TO: Project Manager S/T
I-90 Two Way + HOV operation

Message from Jonathan Dubman <jon@dubman.com> on Mon, 9 Jun 2003 23:59:35 -0700 -----
To: "Tull, Andrea" <tulla@soundtransit.org>
Subject I-90 Two-Way HOV DEIS public
: comment

Draft Environmental Impact Statement Comment Period
April 25- June 9, 2003 (45 days)

I-90 Center Reversible Roadway with 2000 Traffic Counts*

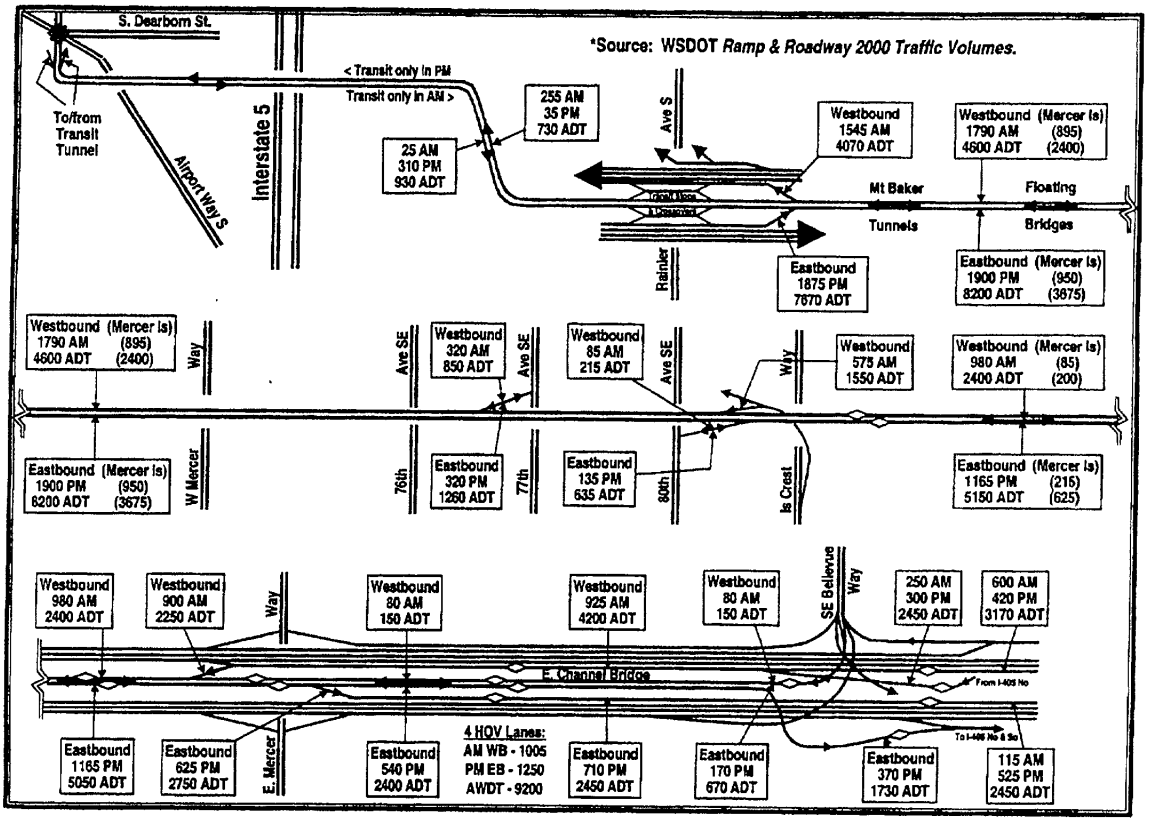
If it weren't for the unbalanced corridor capacity caused by the reversible roadway, the directional split of traffic flow may already show nearly balanced conditions. Analyses of traffic volumes on the SR-520 bridge show that it currently peaks outbound from Seattle during the morning period and inbound to Seattle during the afternoon peak period.

The DEIS has failed to consider the effect of the projected balancing of traffic flows on the I-90 corridor. To most effectively use all capacity of the massive I-90 roadway, much more attention should be given to alternatives that balance I-90's directional capacity.

I-340

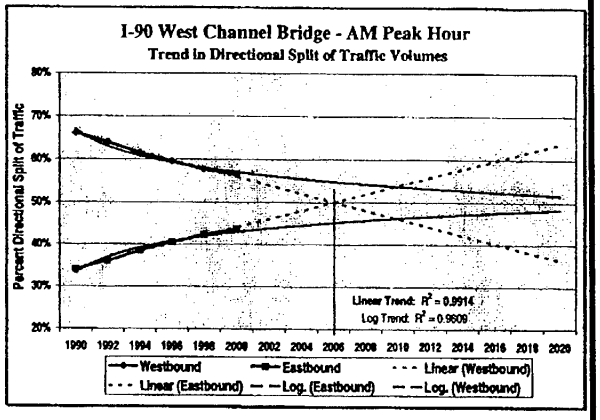
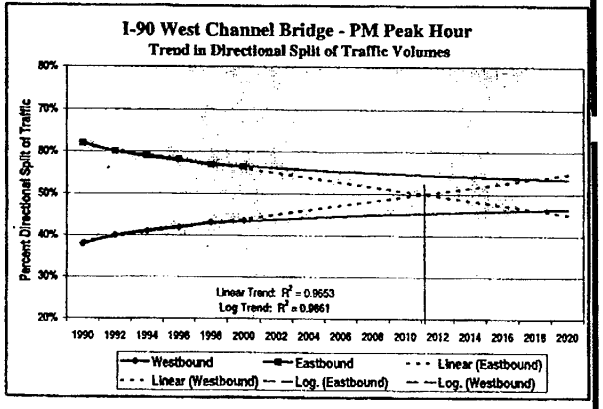
When the I-90 Agreement was developed 30 years ago, Mercer Island's off-island travel was about 70% oriented to/from Seattle. That was the reason for allowing Mercer Island full access to the reversible roadway capacity as a trade-off for eliminating a fourth GP lane each way from Mercer Island to Seattle.

But the travel patterns for Mercer Island have changed even more significantly than the travel patterns for trans-lake travel. As can be seen on the charts, Mercer Island travel is now more greatly oriented to and from the Eastside as compared to Seattle-oriented travel. PM peak hour peak direction travel reversed after 1994. Total weekday trips became more oriented to the Eastside circa 1980. By 2020 both peak hour as well as daily travel will be up to 60% oriented to/from the Eastside. This puts even more pressure on the need to balance the directional capacity of I-90.

I-90/Mercer Island 2000 Traffic Counts

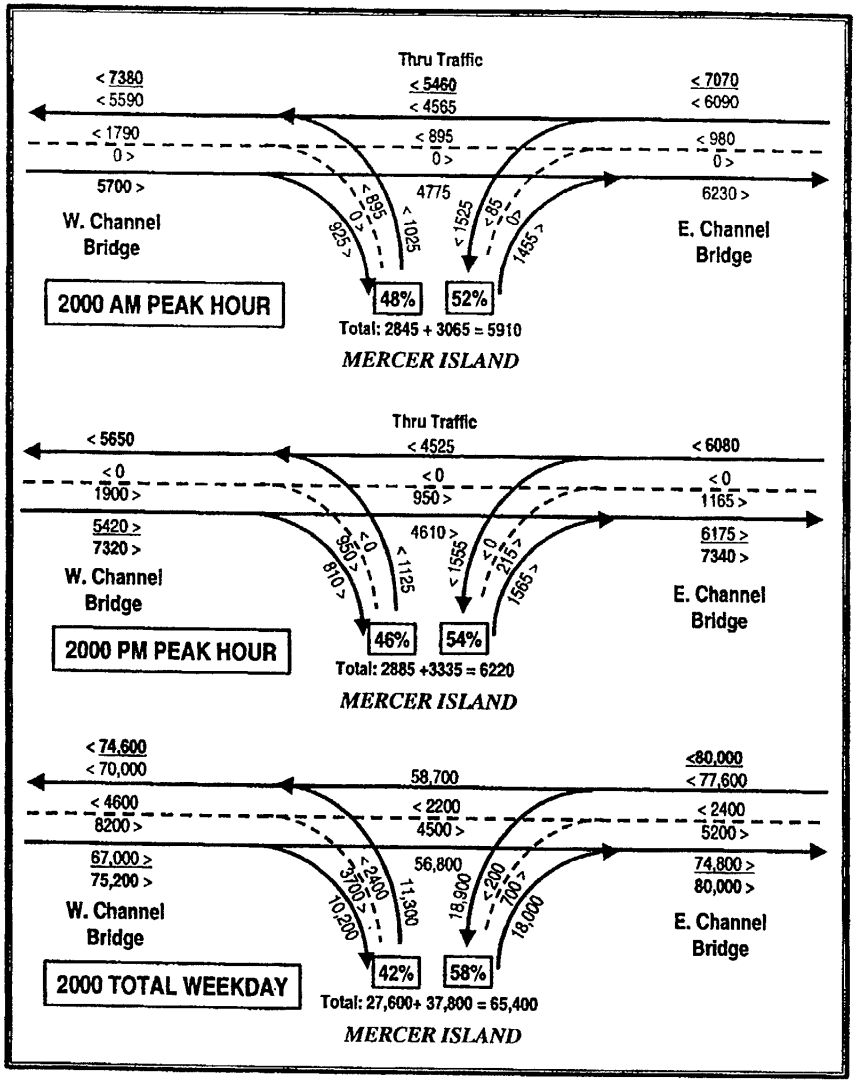
R-2B Plus R-8A?

Your comment is noted.
